FORM APPROVED  
OMB NO. 1004-0135  
Expires: July 31, 2010**SUNDRY NOTICES AND REPORTS ON WELLS**  
*Do not use this form for proposals to drill or to re-enter an abandoned well. Use form 3160-3 (APD) for such proposals.***SUBMIT IN TRIPLICATE - Other instructions on reverse side.**

1. Type of Well <input checked="" type="checkbox"/> Oil Well <input type="checkbox"/> Gas Well <input type="checkbox"/> Other	8. Well Name and No. JENKINS B FEDERAL 10
2. Name of Operator COG OPERATING LLC Contact: KANICIA CASTILLO E-Mail: kcastillo@concho.com	9. API Well No. 30-015-30668-00-S1
3a. Address ONE CONCHO CENTER 600 W ILLINOIS AVENUE MIDLAND, TX 79701	10. Field and Pool, or Exploratory LOCO HILLS-PADDOCK
3b. Phone No. (include area code) Ph: 432-685-4332	11. County or Parish, and State EDDY COUNTY, NM
4. Location of Well. (Footage, Sec., T., R., M., or Survey Description) Sec 20 T17S R30E NENW 850FNL 2310FWL

COG Operating LLC respectfully requests to recompleate this well to the San Andres and change the well type from injection to oil producer.

Jenkins B Federal 8/10  
30-015-30668  
COG Operating, LLC.  
December 02, 2014  
Conditions of Approval

Jenkins B Federal # 10 Wellbore diagram

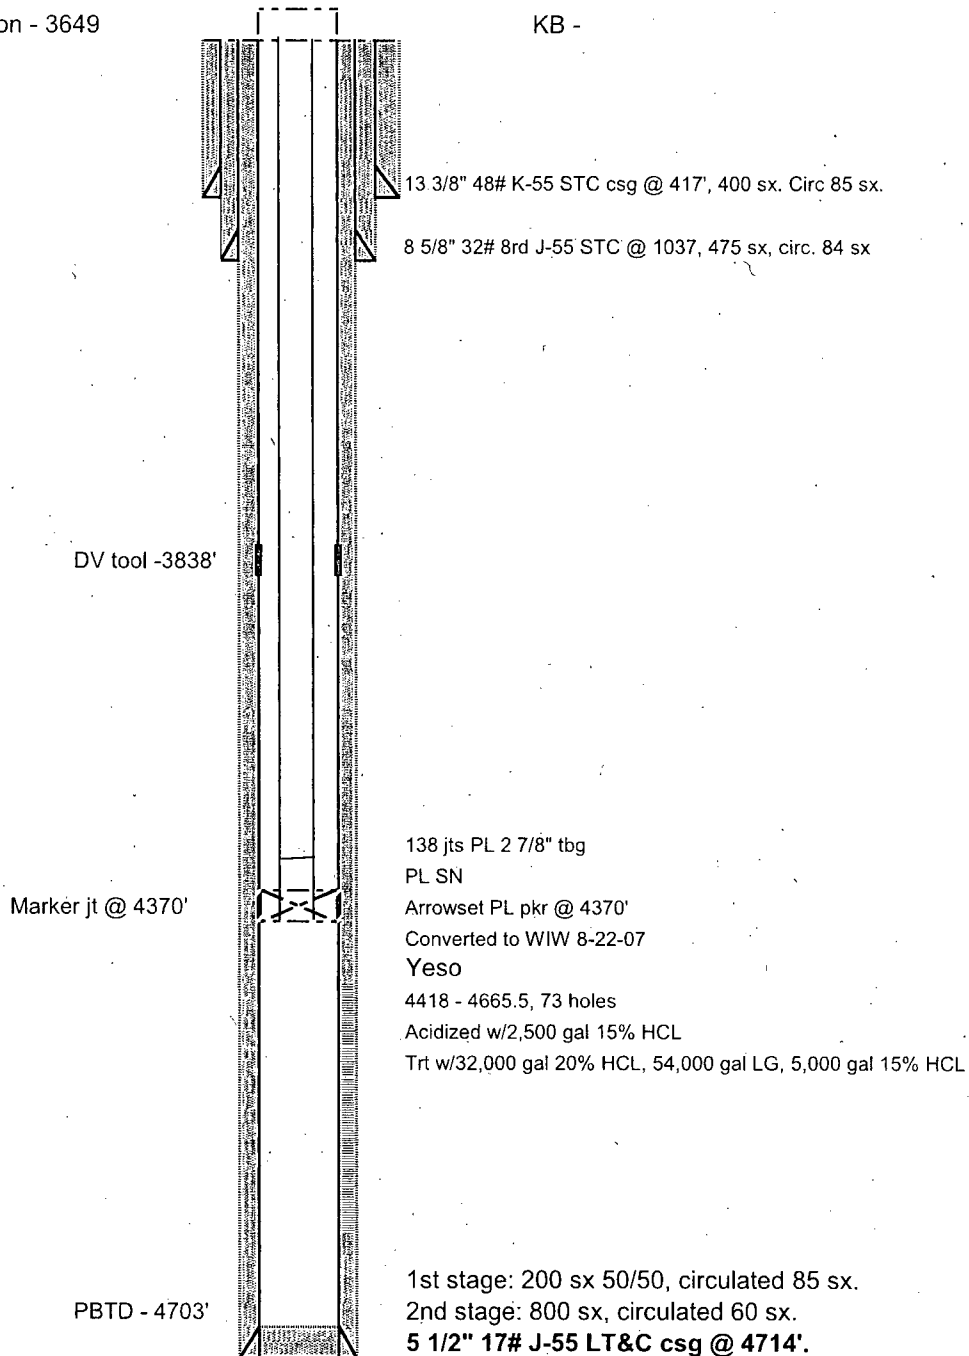
1. Operator shall set a CIBP at 4,350' and place 40' Class C cement on top. Tag required.

**Note:** At a later date, more cement will be required on top of the CIBP when the Glorieta is abandoned.

2. Must conduct a casing integrity test before perforating and fracturing. Submit results to BLM. The CIT is to be performed on the production casing to max treating pressure. Notify BLM if test fails.
